Design Review Committee Meeting

4.II. 3165 Dogwood Drive New Townhomes

PLANNER'S REPORT

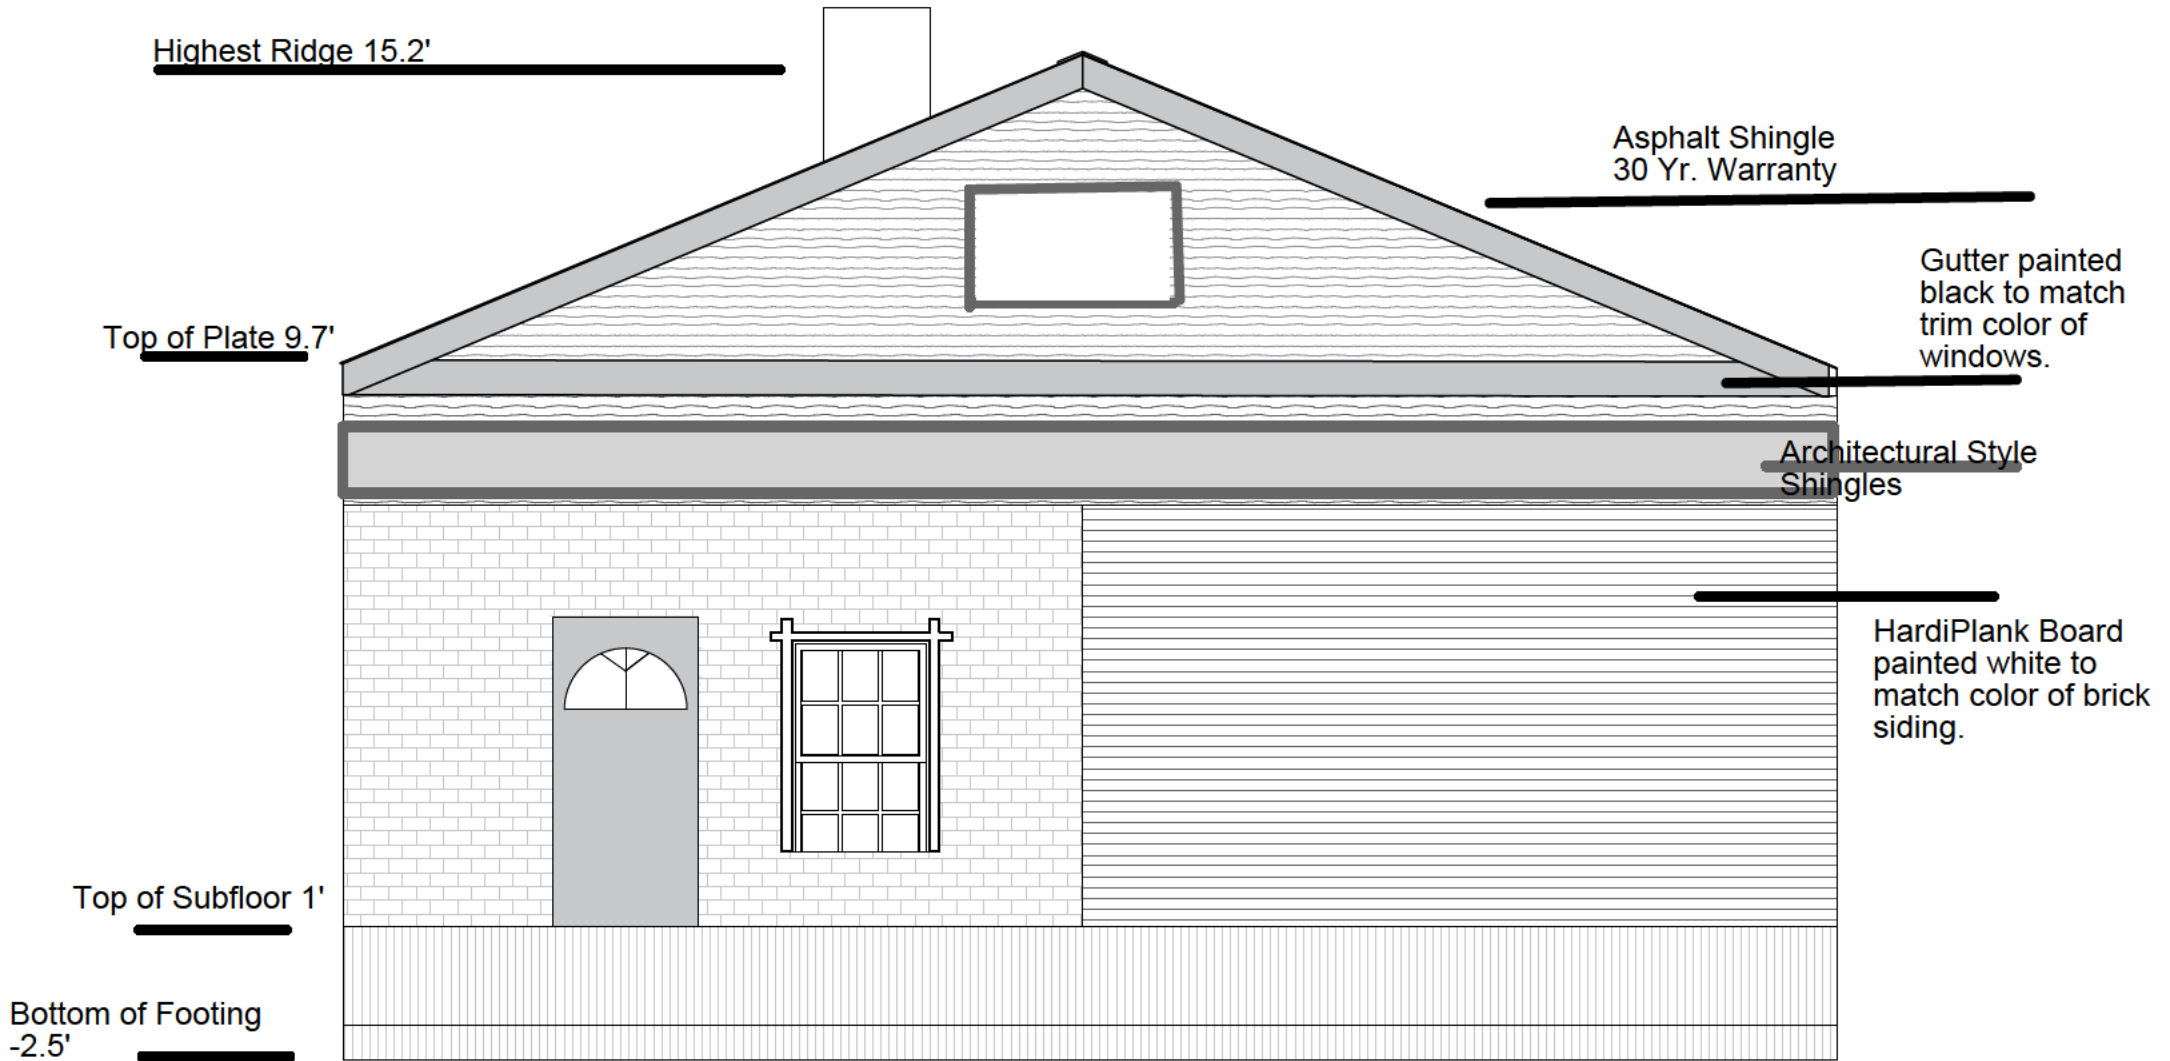
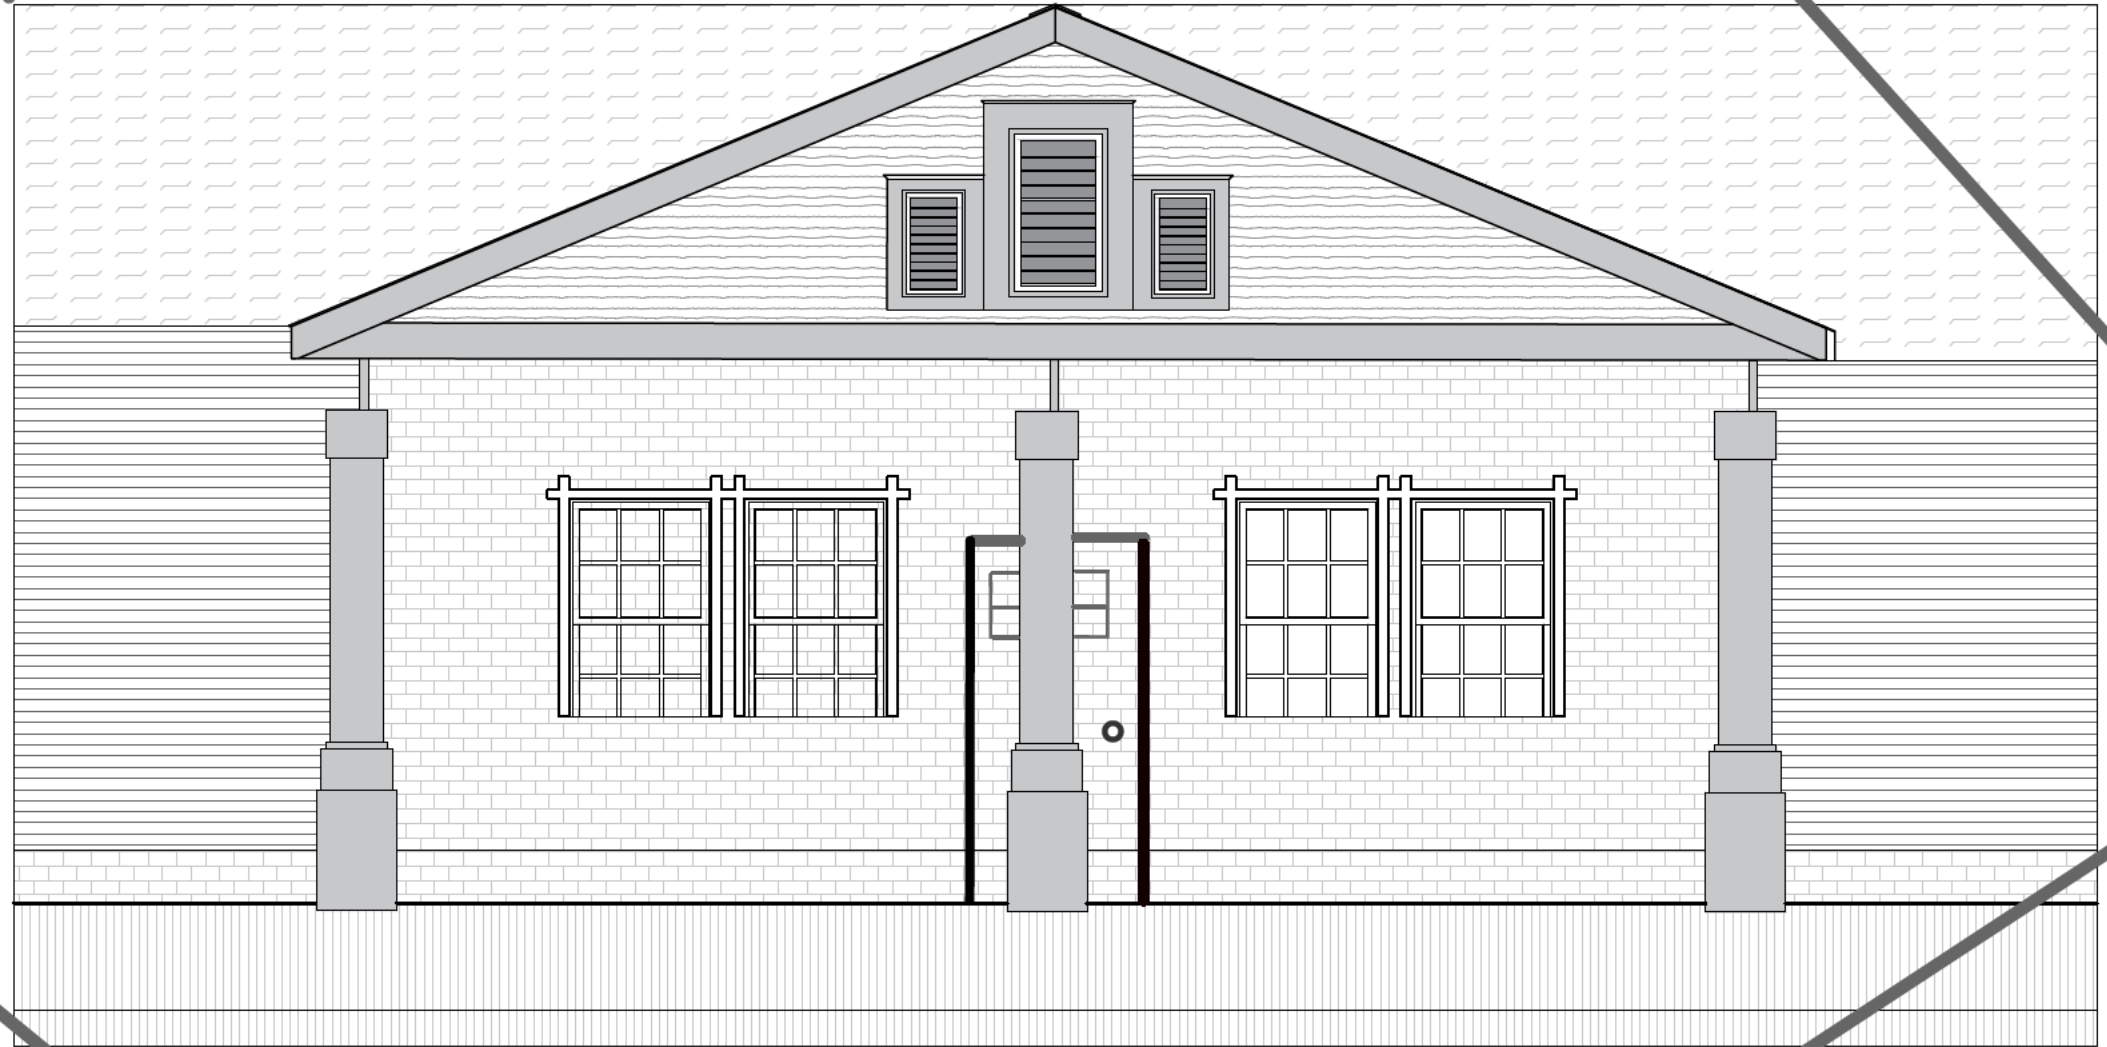
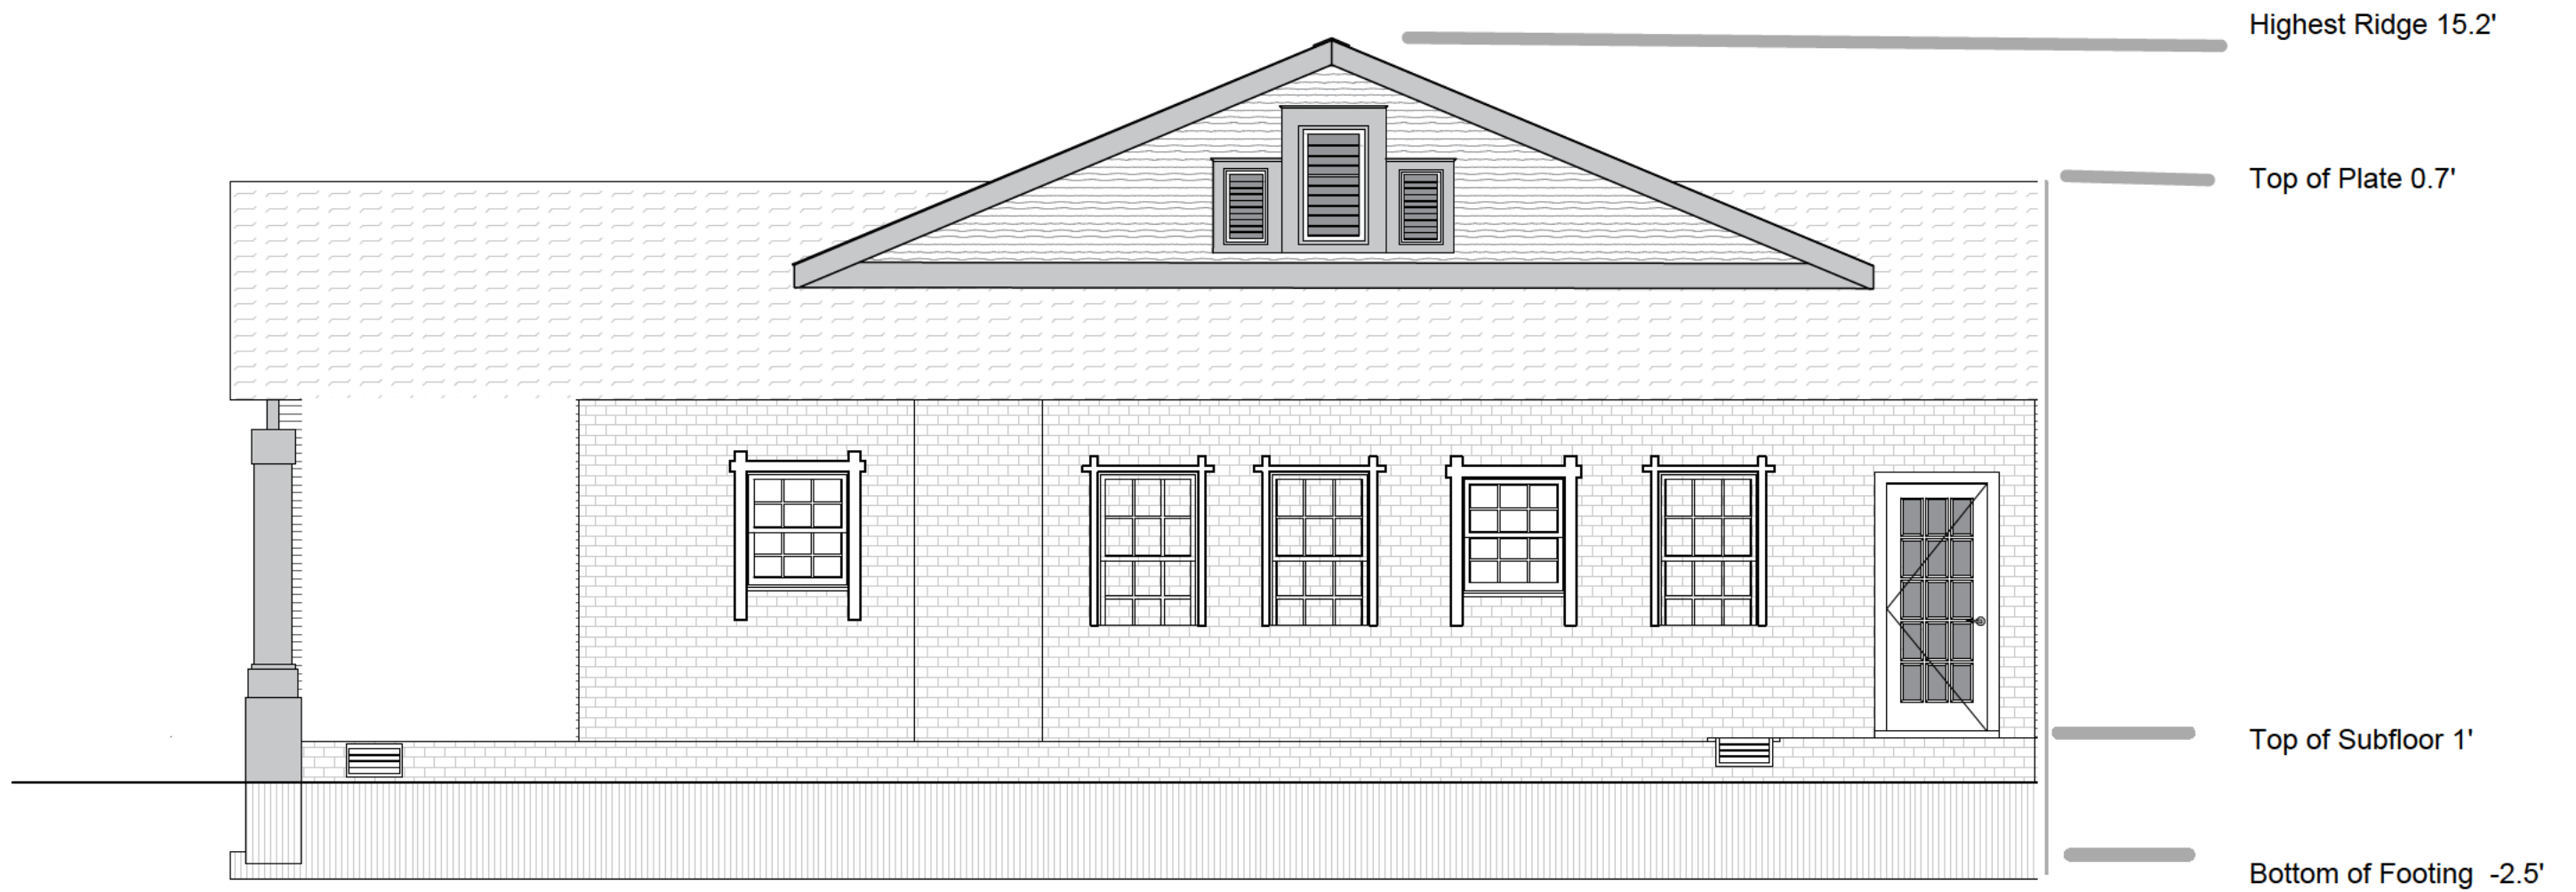
STAFF COMMENT: *The addition should not encroach in the setback. The setback is 5' from the side property line. All eaves must be located outside the setback. .*

- Ensure all of the addition, including the roof eaves is outside of the setback.
- If mechanical is located on the side of the property, it must be screened.
- Provide window detail to ensure compliance.

7 Unit Level Building Rear Elevation 1/8" = 1'-0"

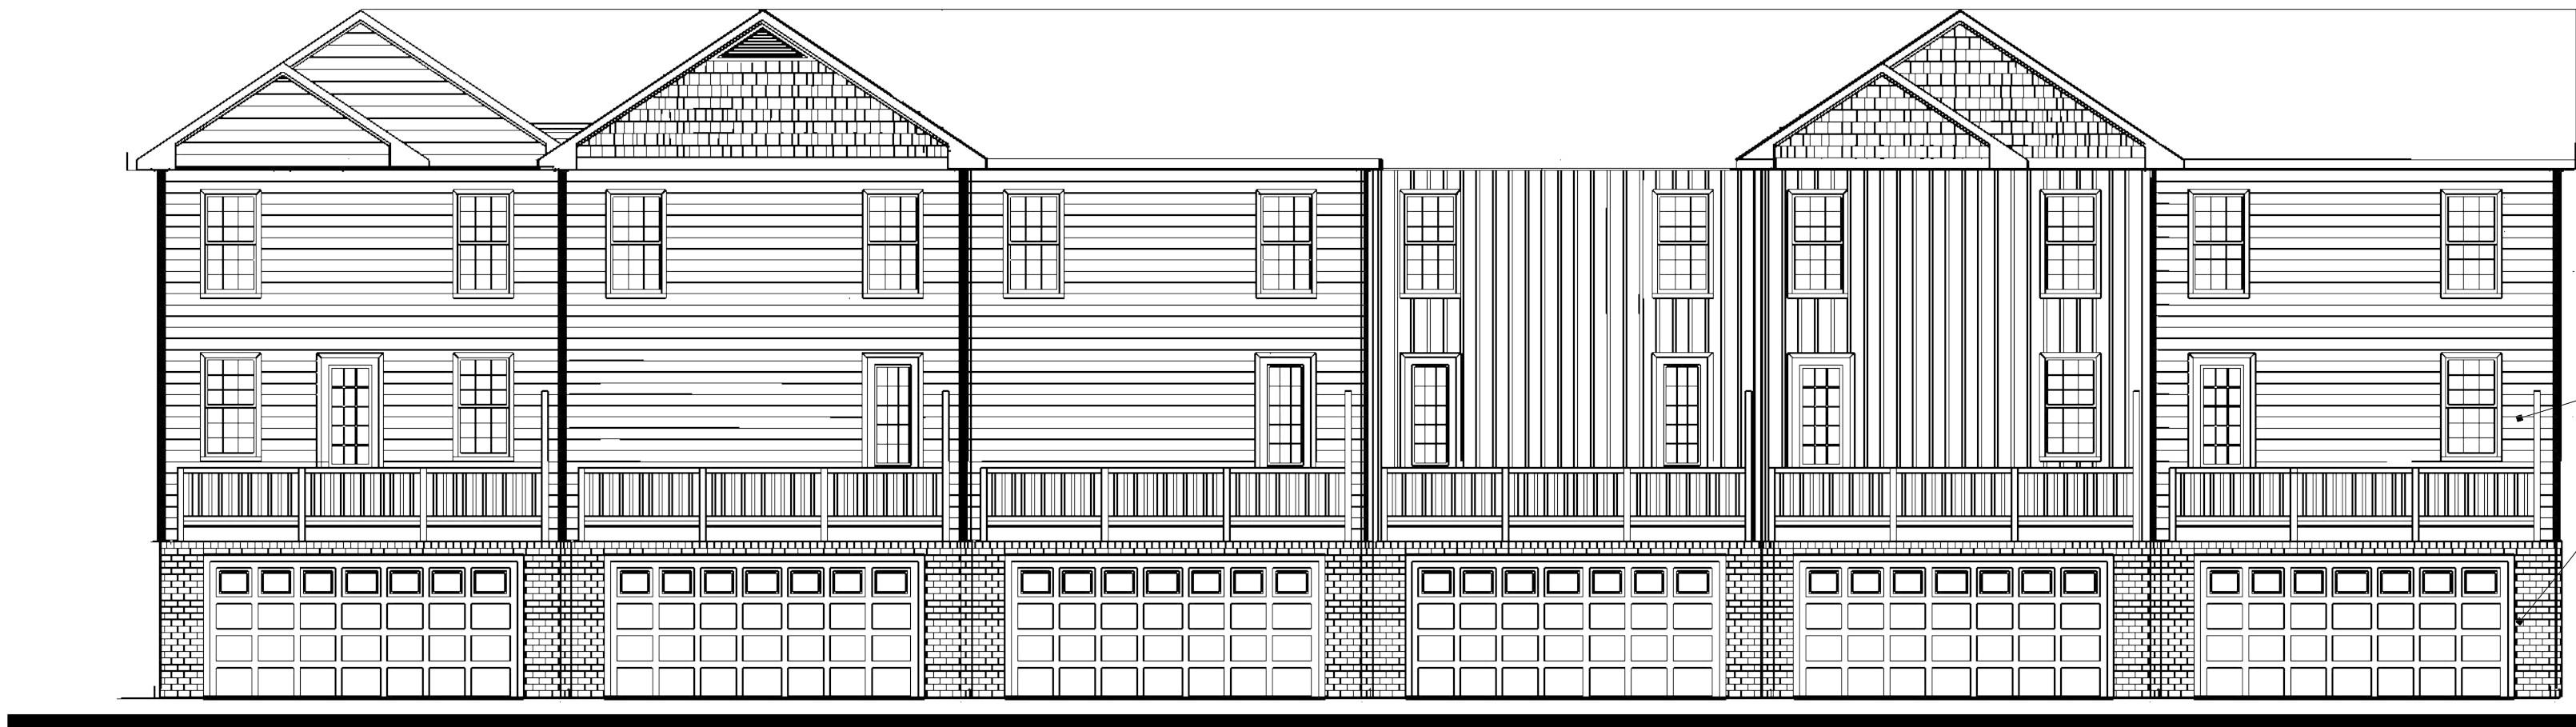
Sheet A 07 references a 7 unit building rear elevation but only 6 units are shown.

Sheet A 07 - The columns are not shown nor are details for the cantilever.
